FINAL PRODUCT/PROCESS CHANGE NOTIFICATION

SUBJECT: ON Semiconductor Final Product/Process Change Notification # 16318

TITLE: CAT25xxx SPI Serial EEPROM New Die Revision with Timing Specification Change

a) New Die Revision

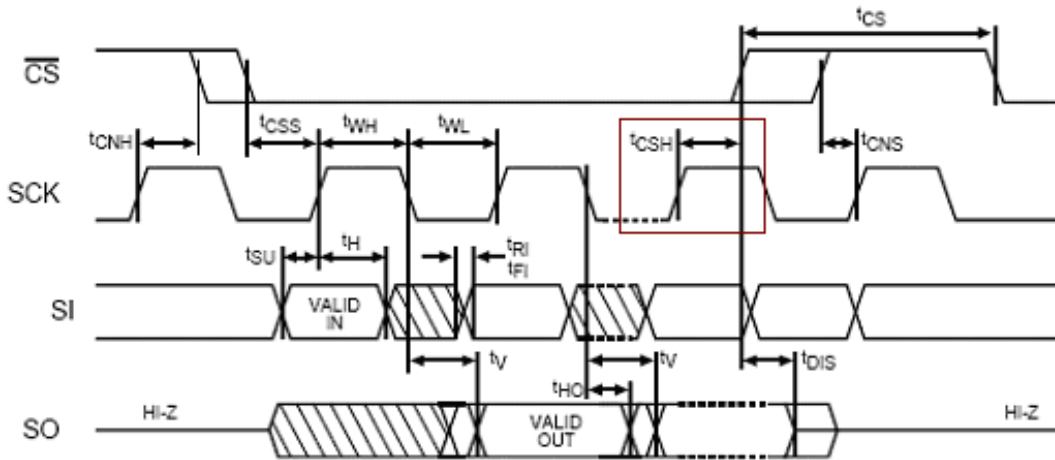
For the new die revision, the Chip Select (CS) input low to high transition timing is changed to be defined relative to the rising edge of the clock input, independent of SPI mode (0, 0) or (1,1). In the earlier die revisions, the CS input low to high transition was recognized (latched) on either the positive or the negative transition of the clock input - as a function of SPI mode.

t_{CSH} value – New Die Revision

Symbol	Parameter	VCC = 1.8V – 5.5V / -40°C to +85°C VCC = 2.5V – 5.5V / -40°C to +125°C		VCC = 2.5V – 5.5V -40°C to +85°C		Units
		Min	Max	Min	Max	
t_{CSH}	CS Hold Time	30		20		ns

Example of Ordering Information: CAT25640 Die Rev. E

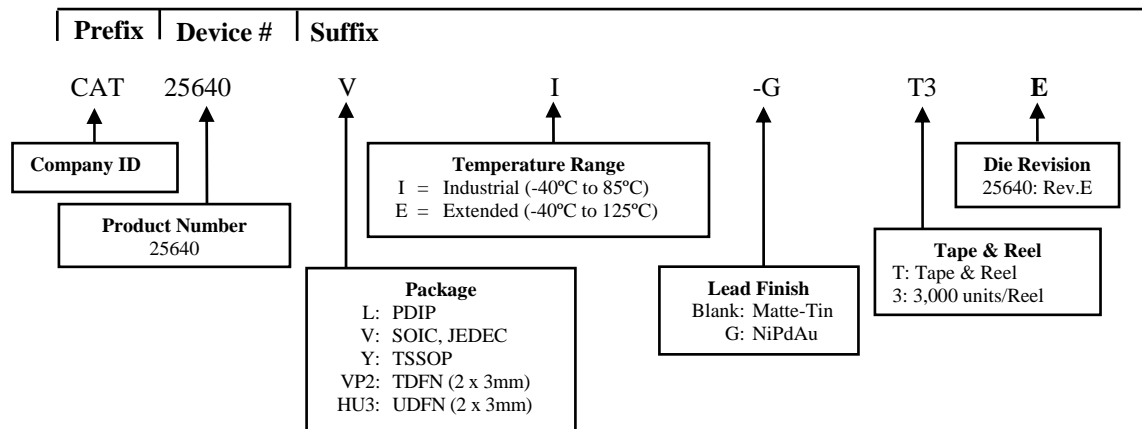
The orderable part number for the new die revision will have the product revision letter added in the end of part numbering.
